ADDENDUM No. 2

ITB No. 4561

WTP LIME RESIDUAL REMOVAL CONTRACT No. 2 – DREDGING AND HAULING

SHEET NO. 25 OF 39

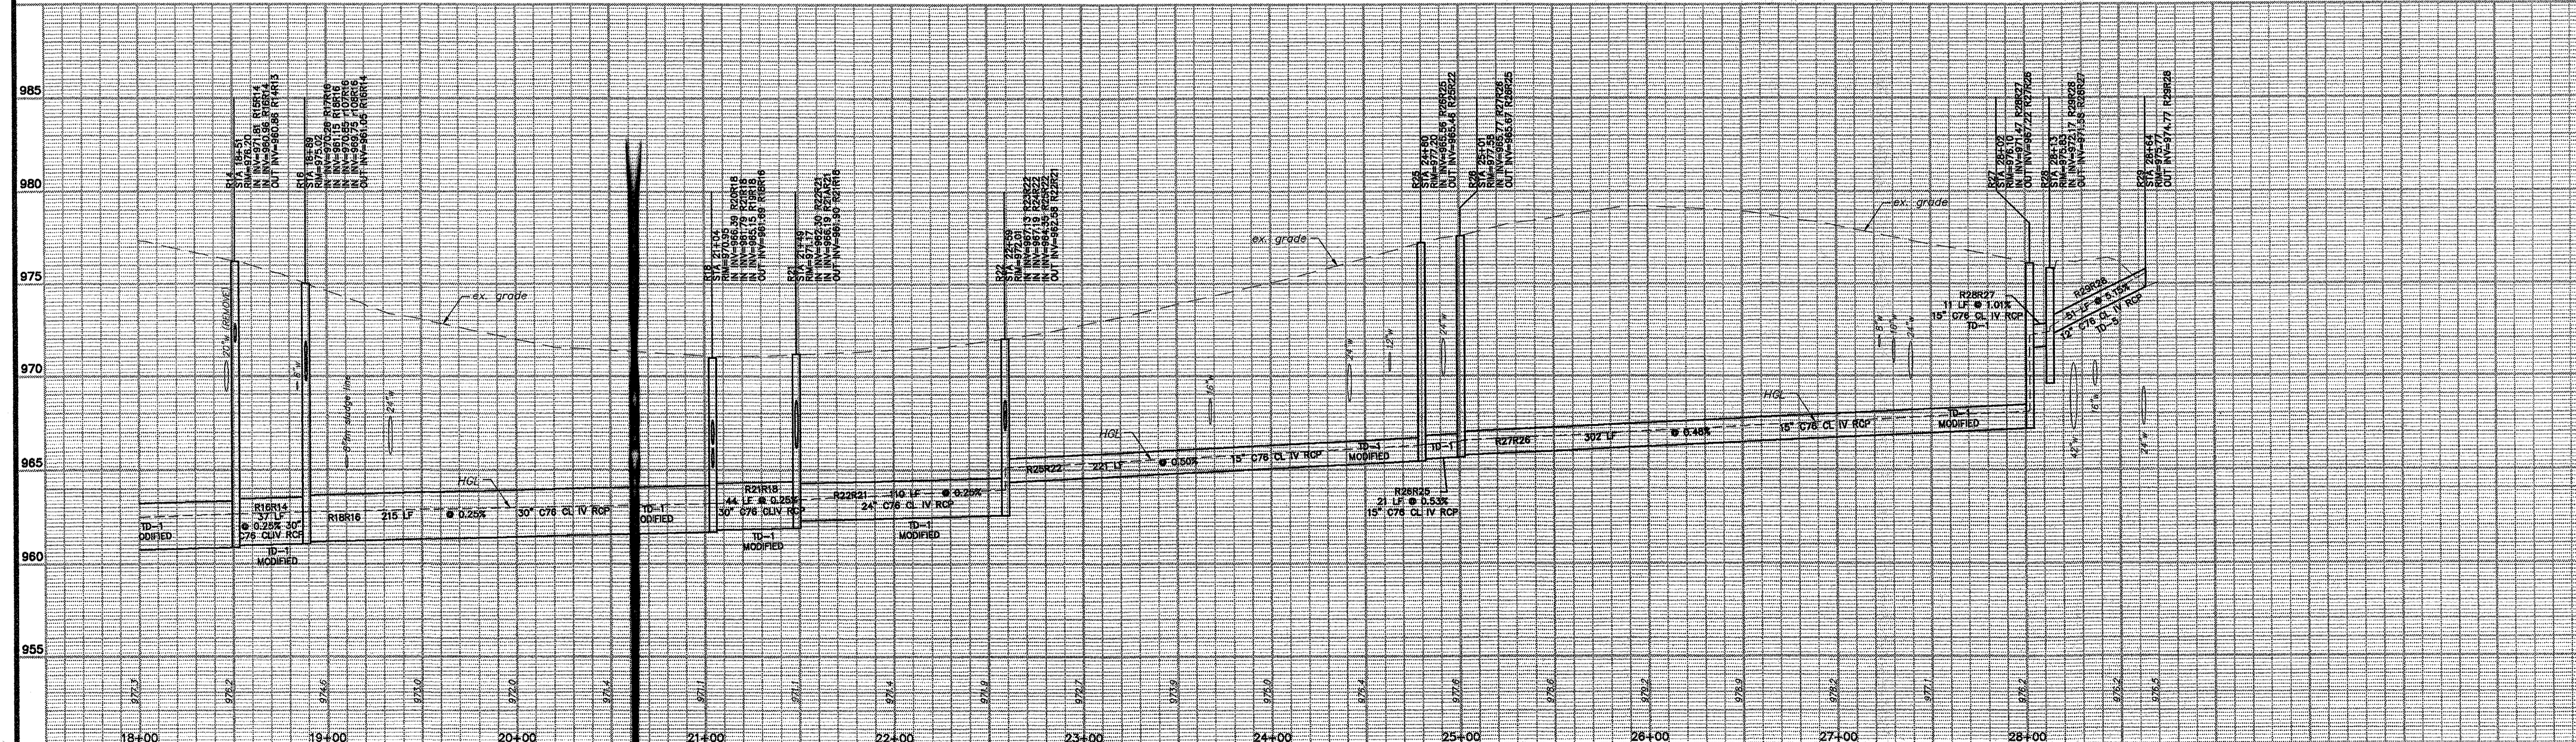
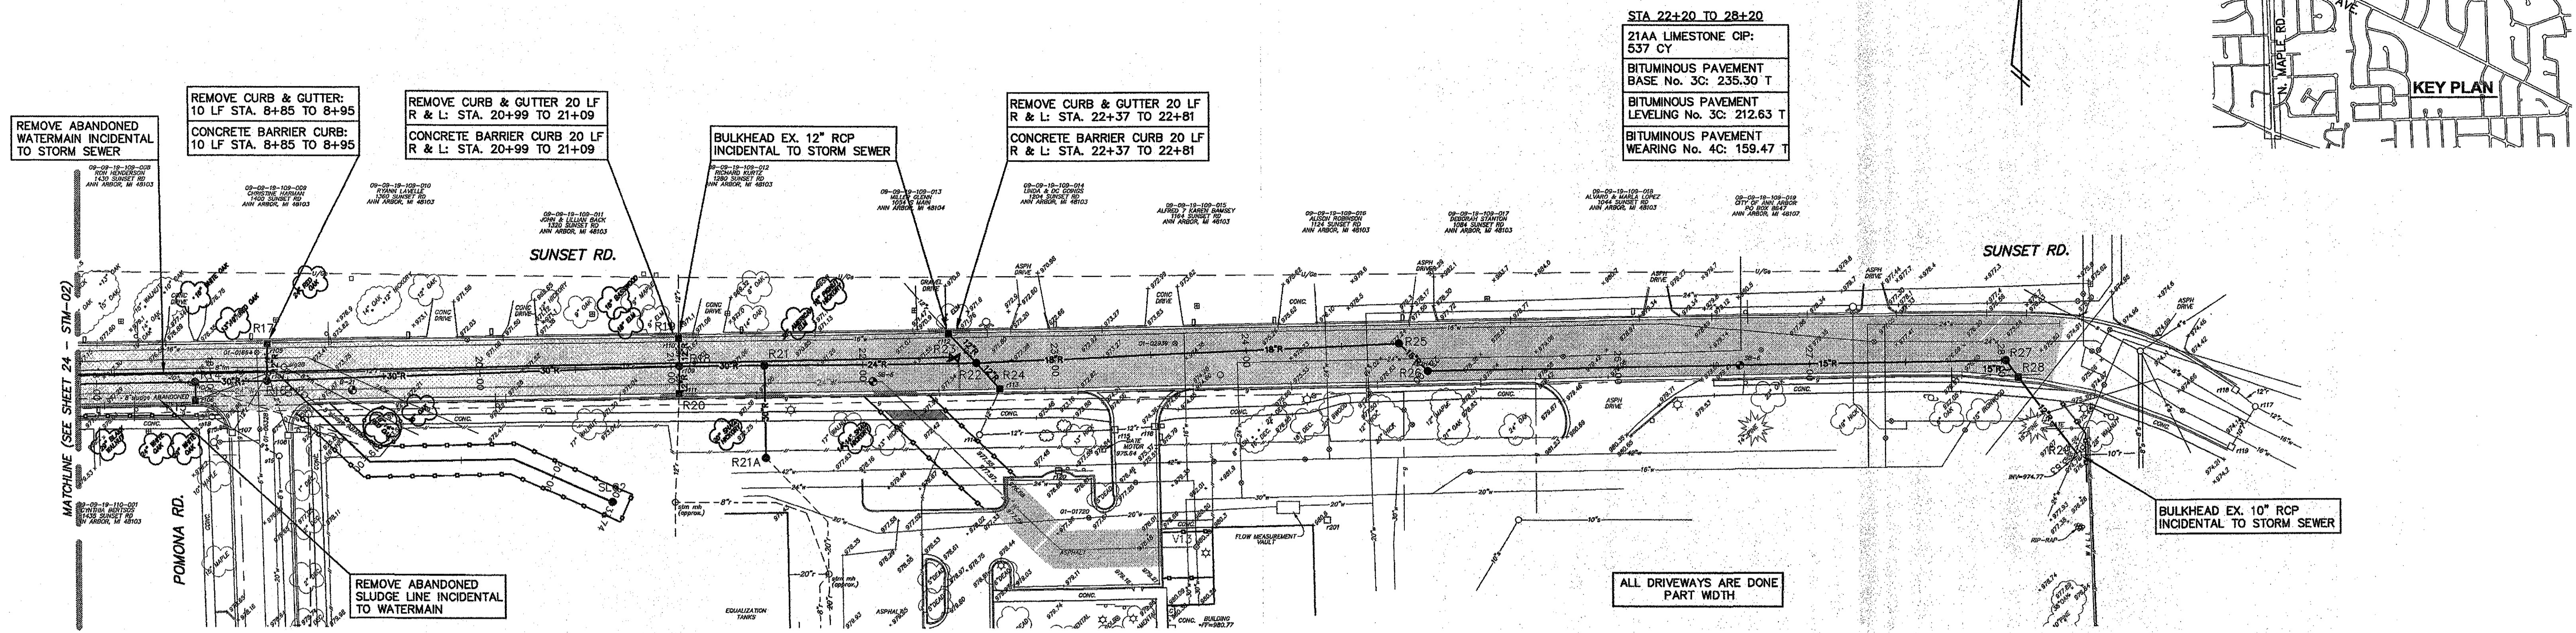
Q: Please provide the carrying capacity of the existing line that will be used to return the filtrate water back to the lagoon.

A: See attached record drawings of the 30-inch storm sewer. (3 pages)
